METROPOLITAN GOVERNMENT OF NASHVILLE AND DAVIDSON COUNTY

STAFF RECOMMENDATION
1724 4th Avenue North
December 20, 2017

Application: New construction-infill and outbuildings
District: Salemtown Neighborhood Conservation Zoning Overlay
Council District: 19
Map and Parcel Number: 08205008200
Applicant: Quirk Designs
Project Lead: Paul Hoffman; paul.hoffman@nashville.gov

Description of Project: Application for infill construction of new duplex and carports.

Figure 2. Staff recommends moving this bay to the right side to read as part of the projecting gable above

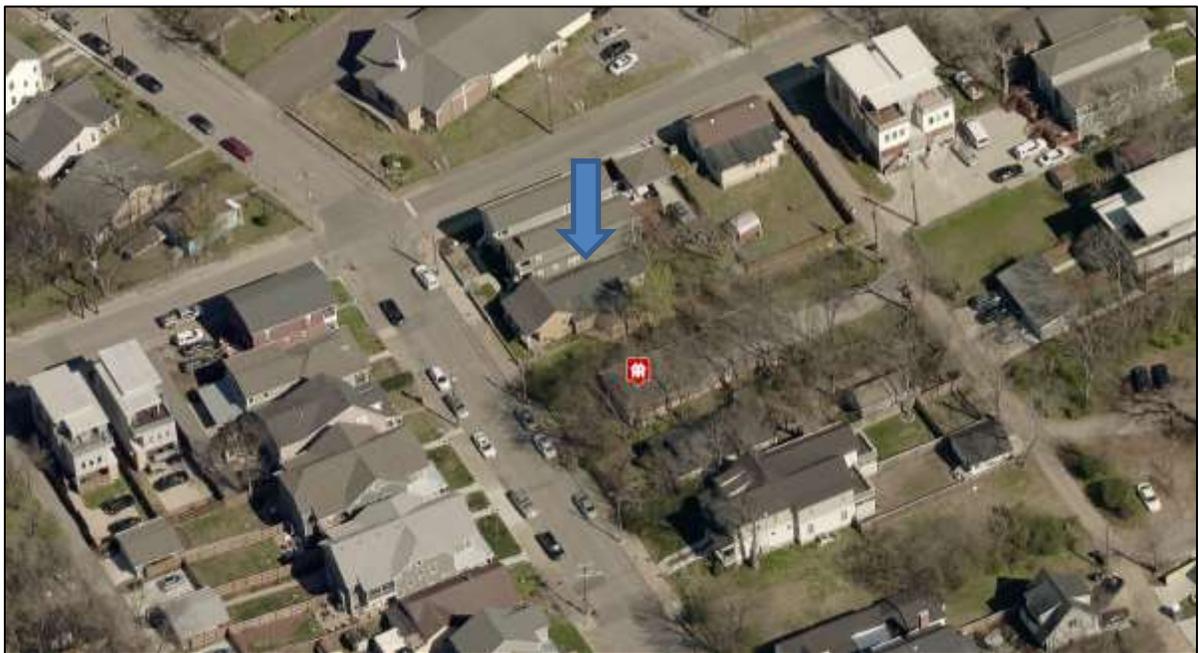
The new structure will be thirty-nine feet, eight inches (39' 8") wide. Contributing homes on the block are as wide as thirty-six feet (36'). Recently-approved new construction has been permitted as wide as forty feet (40'). The bay on the left side of the porch reads as an enclosed portion of the porch. As this is a feature not typically seen historically, staff recommends moving the bay to the right side, for that portion to read as a gabled-ell form under the projecting gable above it.

With the condition that the height of the front-facing gable is reduced to thirty-five feet (35') or less from grade, and the projecting porch bay is moved to the right side of the structure, Staff finds that the project meets Sections III. A and B for height and scale.

SITE PLAN

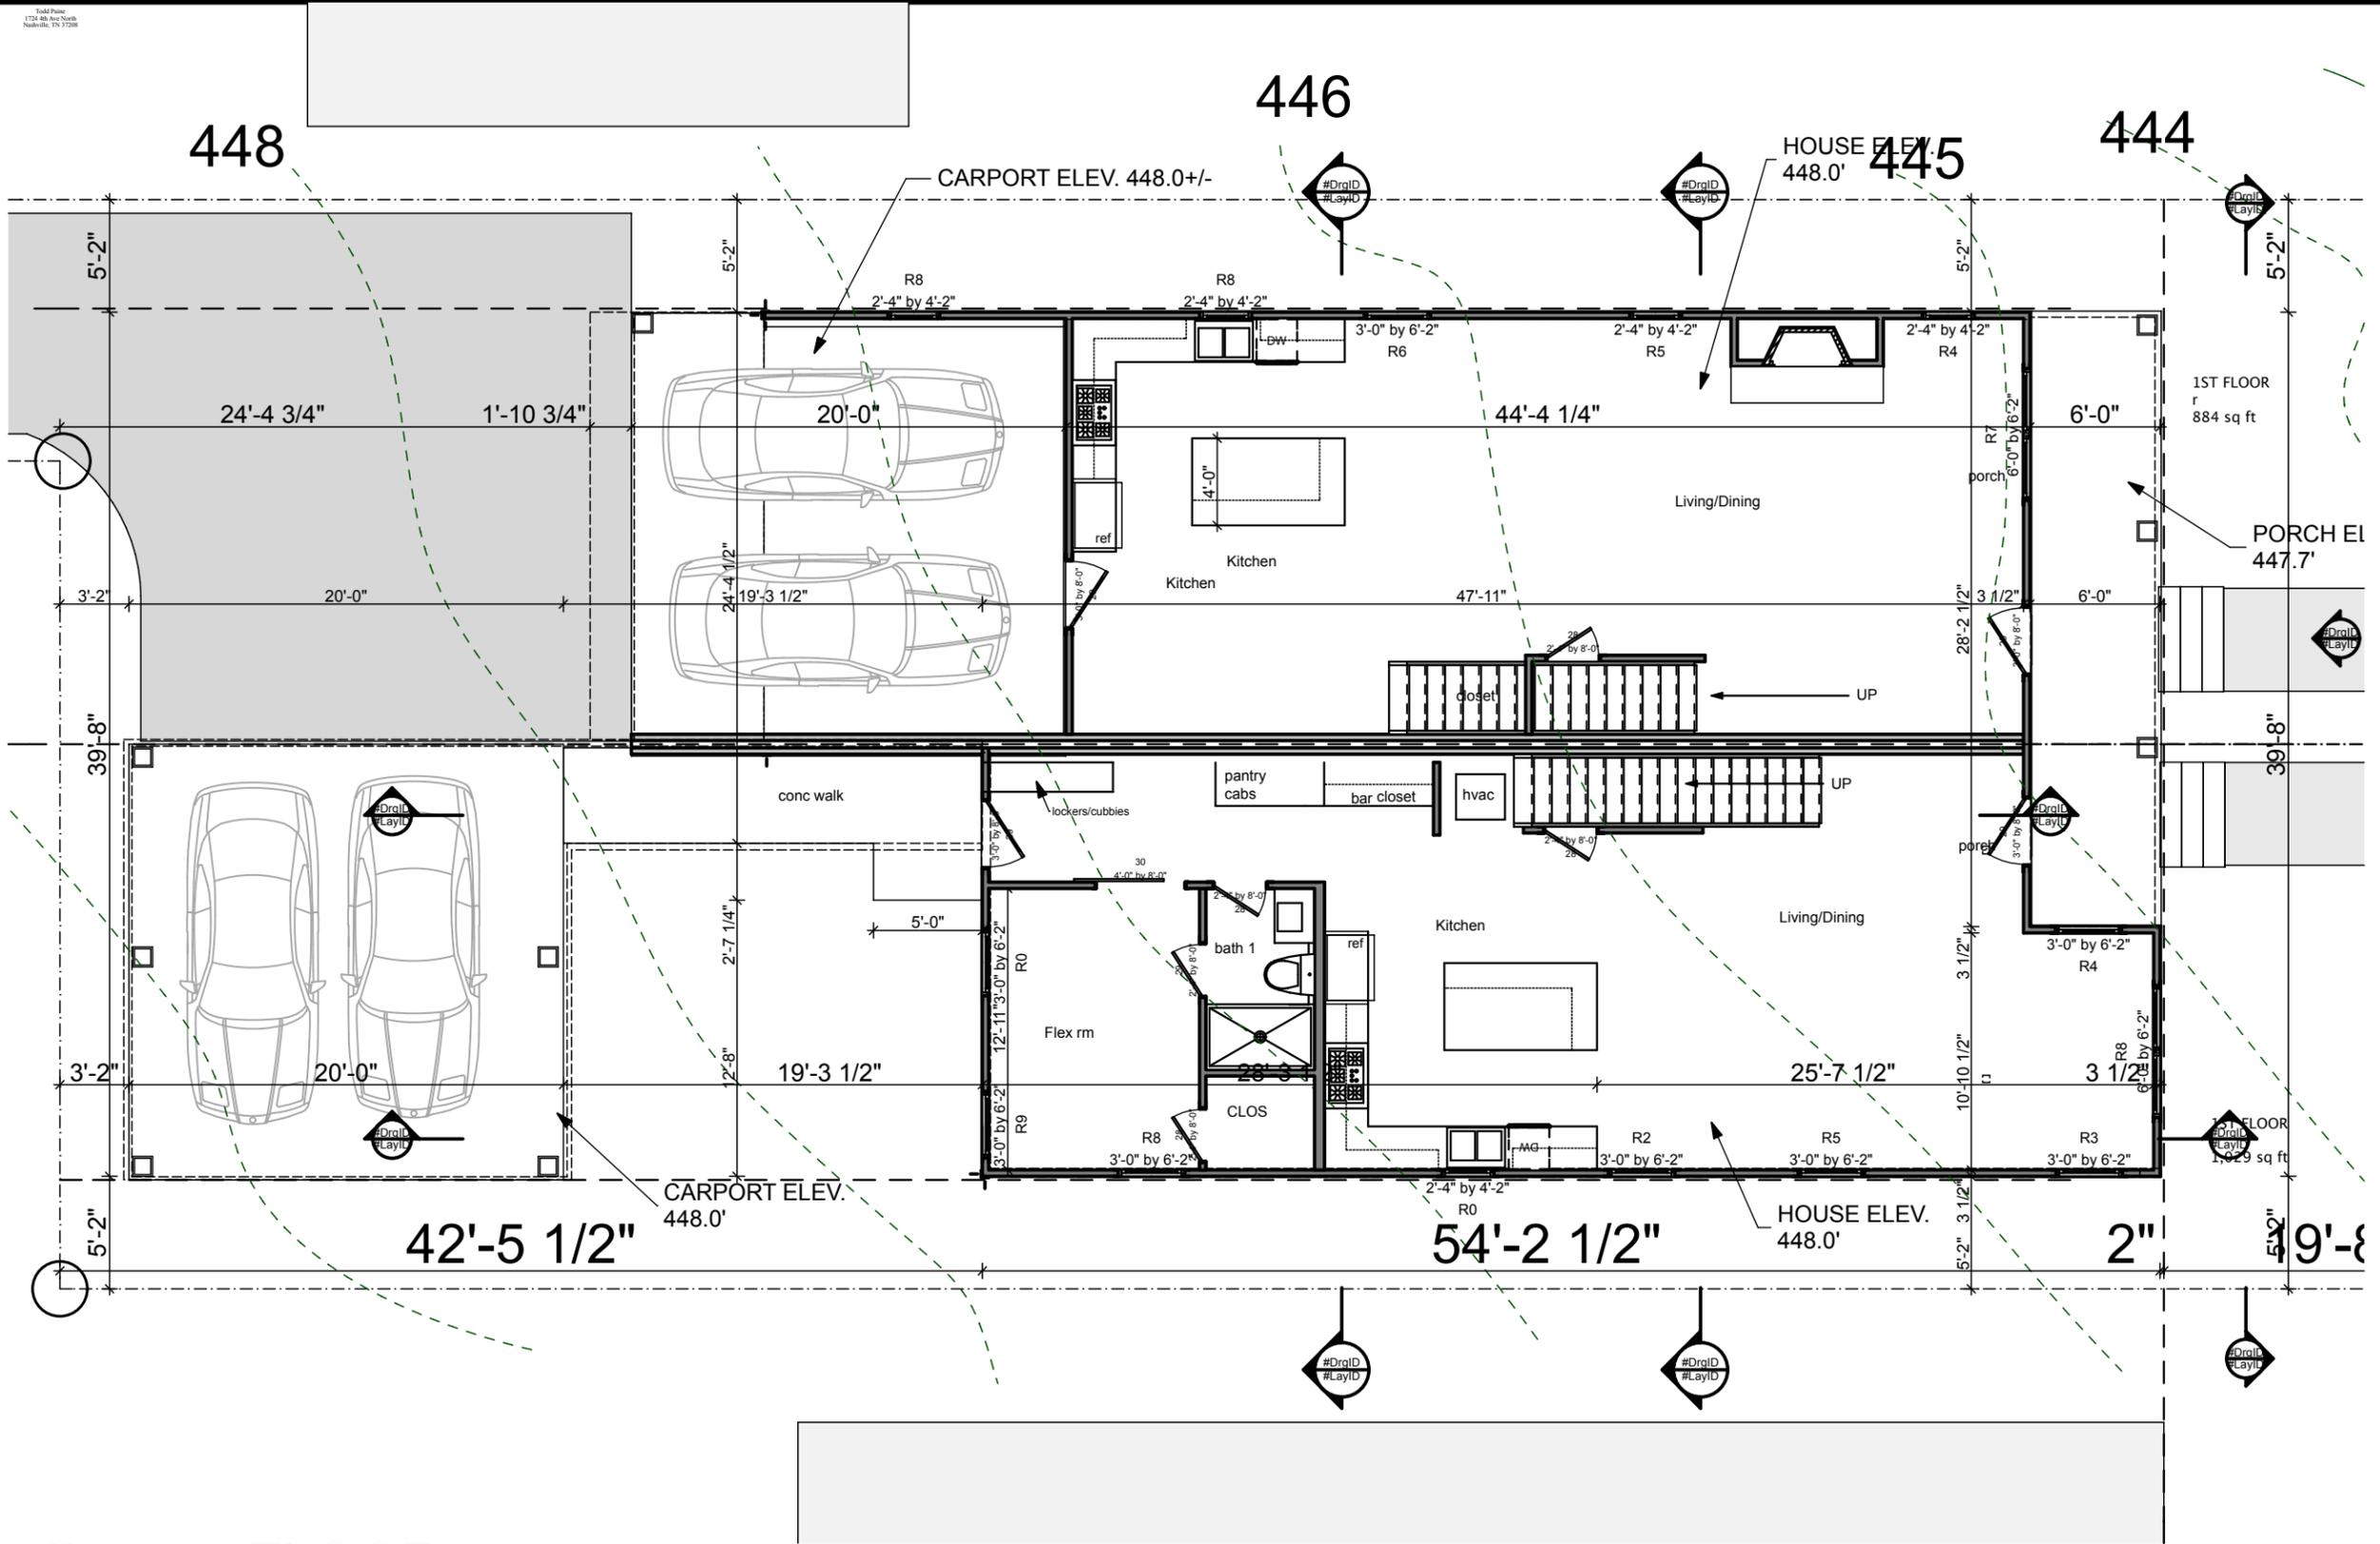
Setback & Rhythm of Spacing: The infill meets all base zoning setbacks. It will be five feet, two inches (5' 2") from each side property line, meeting the base zoning requirement of five feet (5'). The form is staggered, so the rear wall of the units will be forty-two feet, five inches (42' 5") and fifty feet (50') from the rear property line, which meets the required twenty feet (20') rear setback. The front setback will be nineteen feet, eight inches (19' 8") from the front property line, matching the setback of the neighboring building to its left. The nearest contributing building is two doors away and is set back from the street approximately twenty-five feet (25'). The lot is an unusual size and shape because of the subdivision of the adjacent lot behind it. Due to the truncated lot, Staff finds the front setback matching the neighboring structure to be appropriate. Staff finds that the project meets Section III.C for setback and rhythm of spacing.

Outbuilding: The application includes an attached carport for each unit. Attached outbuildings would not normally be appropriate. However, the lot is oddly-shaped and sized, and detached outbuildings would be impracticable. In this case Staff finds the attached carport to be appropriate due to the constraints of this lot. Each outbuilding is four hundred square feet (400 sq. ft.), for a total of eight hundred square feet (800 sq. ft.)

for both. Section III.H.1 of the design guidelines limits the total size of an outbuilding to seven hundred fifty square feet (750 sq. ft.). Staff recommends as a condition of approval that the outbuildings not exceed this amount. With this condition, Staff finds that the project meets Section III.H of the design guidelines for outbuildings.
